Our ref. : KFQCDM-16

Response to Request for Review

‘Yunnan Youfanggou Hydropower Project (Ref. 3082)’

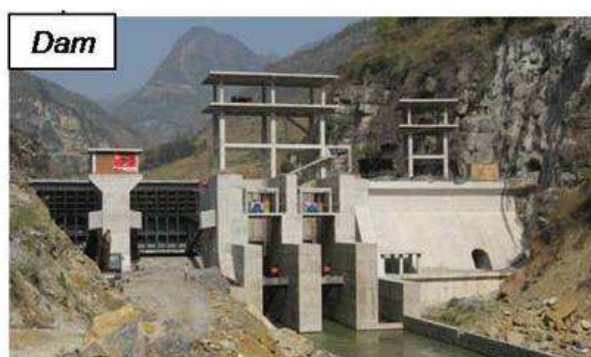
The DOE is requested to substantiate how it has validated the suitability of: a) the co-efficient of effective electricity (0.9); and b) the conservativeness of a residual value of zero; considered in the investment analysis. The application of a co-efficient of 1, yields an IRR above the benchmark.

As shown in the photograph of the Youfanggou project under construction, the dam of the project is relatively low (27.5 m) and the reservoir shallow giving limited reservoir capacity of 7.82 million m³. Therefore the Youfanggou project only has daily water regulating capacity¹ and thus falls under category 3. *Grid connected, monthly/weekly/daily regulating hydropower stations* in Table 1 above. It is the smallest scale project in this category (i.e. daily rather than weekly or monthly) and so the CEE should be at the bottom of the range of 0.7 to 0.9. Conservatively however the highest possible factor of 0.9 has been selected.
